CITY OF SANTA BARBARA

COUNCIL AGENDA REPORT

SUBJECT: Appeal Of Single Family Design Board Denial Of A Residence On Lot 2 Of The 3626 San Remo Drive Subdivision

1st SFDB Review
January 13, 2014

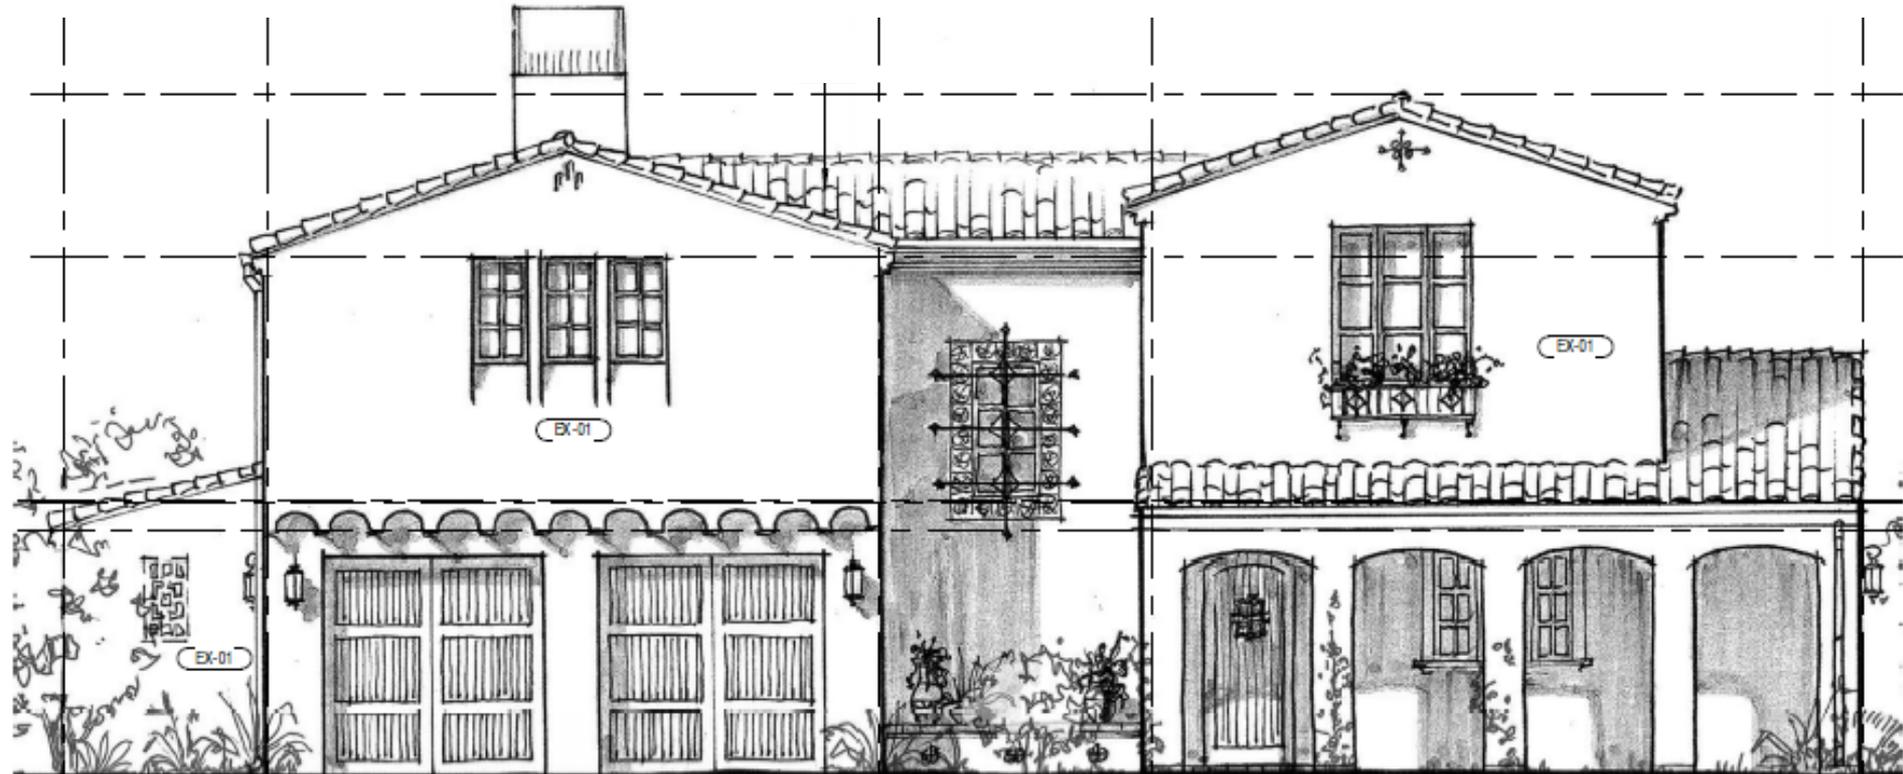
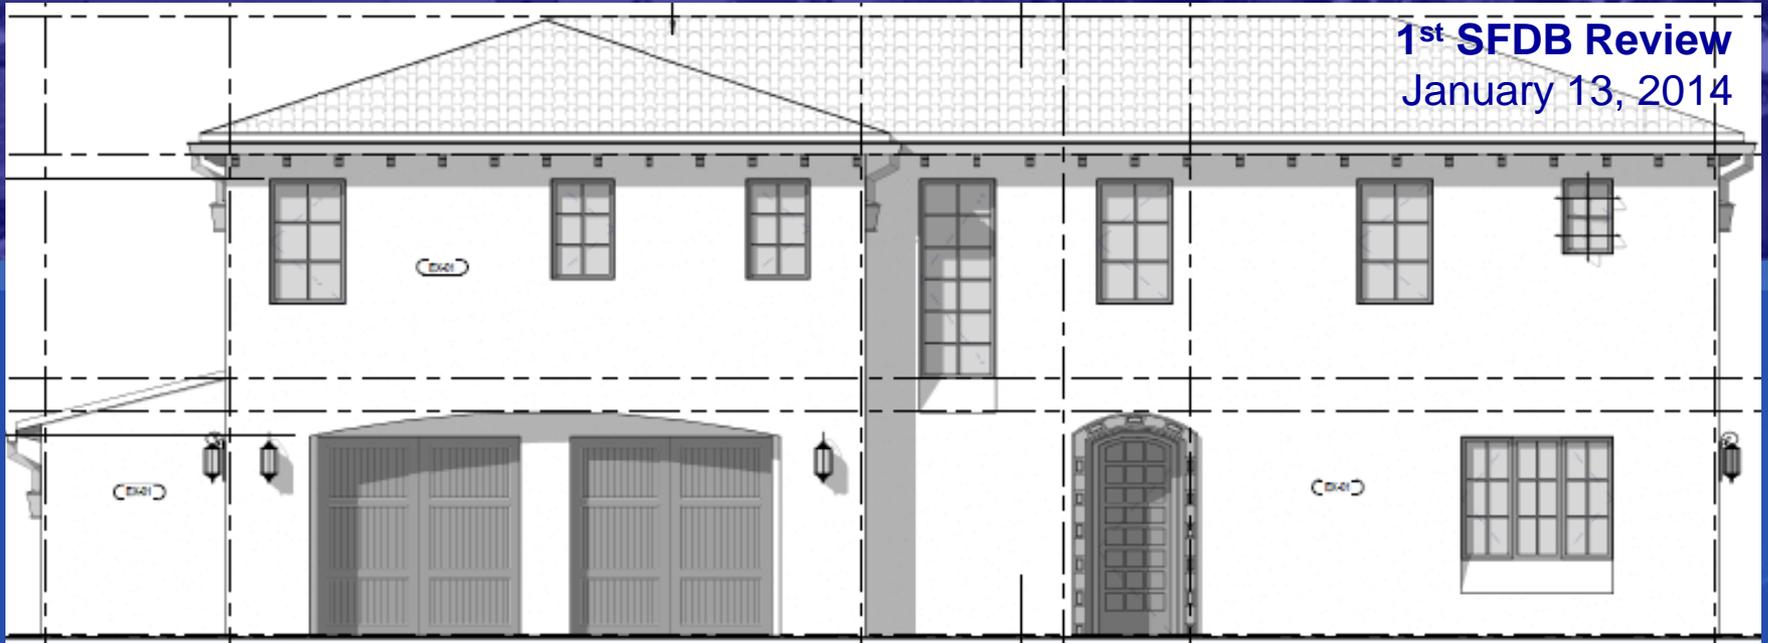
- 1) Reduce the square footage.
- 2) Study of the second-story.
- 3) Consider reducing the roof height.
- 4) Create an arbor-type entrance to help mitigate the façade.
- 5) Study the sloped walls below the windows.
- 6) Provide story poles.
- 7) Consider Lot 4's design as the design for Lot 2.

- Motion:** Continued indefinitely to Planning Commission to return to Full Board with comments:
- 1) The Board appreciates the changes in architecture.
 - 2) Reduce plate height and square footage.
 - 3) Study locations for guest parking.
- Action:** Woolery/James, 6/0/0. Motion carried. (Pierce stepped down).
